## **Proposal for Supplement 6 to the 02 series of amendments to UN Regulation No. 117 amending document ECE/TRANS/WP.29/GRB/2013/10**

**Note:** The text reproduced below was prepared by the experts from the Russian Federation as a result from the ad-hoc working group meeting of experts of NAMI (the Russian Federation) and UTAC (France), with the participation of ETRTO organized in accordance with the recommendation of the 58<sup>th</sup> GRB session (ECE/TRANS/WP.29/GRB/56, para. 15), which endorsed to test the proposed "Deceleration Calculator" tool. This proposal amends document ECE/TRANS/WP.29/GRB/2013/10 distributed at the 58<sup>th</sup> GRB session. The physic-mathematic principle in this document is not changed relatively to the previous one, but the text of explanations is considerably modified. The modifications to the existing text of the UN Regulation are marked in bold for new or strikethrough for deleted characters.

Figure 1.

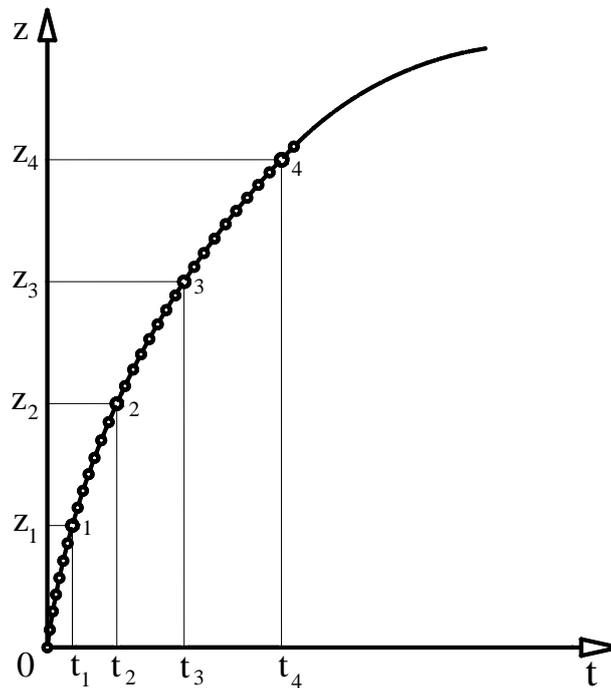
1. **Record dependency "distance-time" of rotating body decelerated from peripheral with a speed range such as 82 to 78 km/h or 62 to 58 km/h dependently of PC or CV tyre in a discrete form (figure 1) for rotating body:**

2. Approximate recorded dependency by continuous, monotonic, differentiable function:
  - 2.1. Choose the nearest to the maximum value of  $z$  dividable by 4 and divide it on 4 equal parts with bounds:  $0, z_1(t_1), z_2(t_2), z_3(t_3), z_4(t_4)$ .

4.2. Finding the value nearest to the maximum z equals n, dividable by 4, dividing it on 4 equal parts and recording the coordinates of 4 points on the experimental curve (see figure 1).

4.3. Working out the equation system on the base of formula from paragraph 2.3 of Annex 6 - Appendix 5 with substitution of 4 point coordinates as shown on Figure 1:
